EXISTING DEACON PUMPING STATION

DRAWING NO. WM-E004-SK-1-Rev1

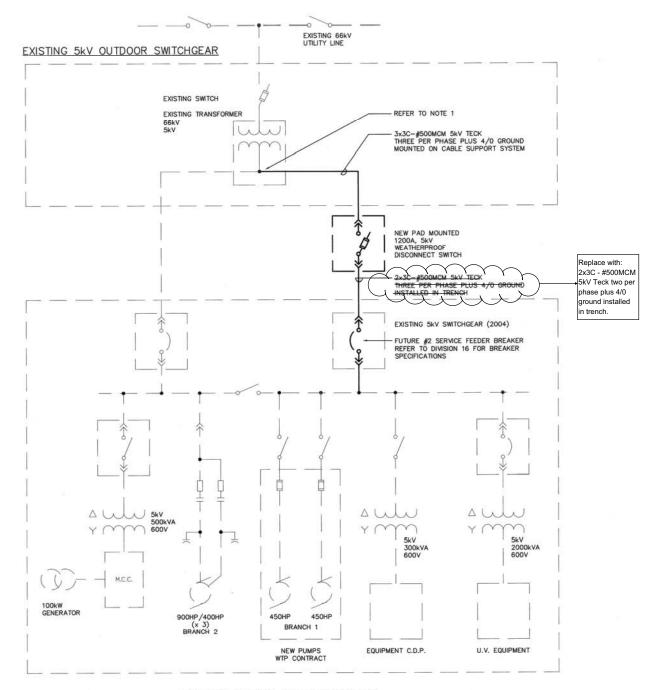
PROVIDE TWO (2) HOLE LONG BARREL COMPRESSION LUGS FOR CABLE CONNECTION TO SECONDARY TERMINALS ON EXISTING TRANSFORMER. MODIFY CONNECTION TERMINATIONS AS REQUIRED.
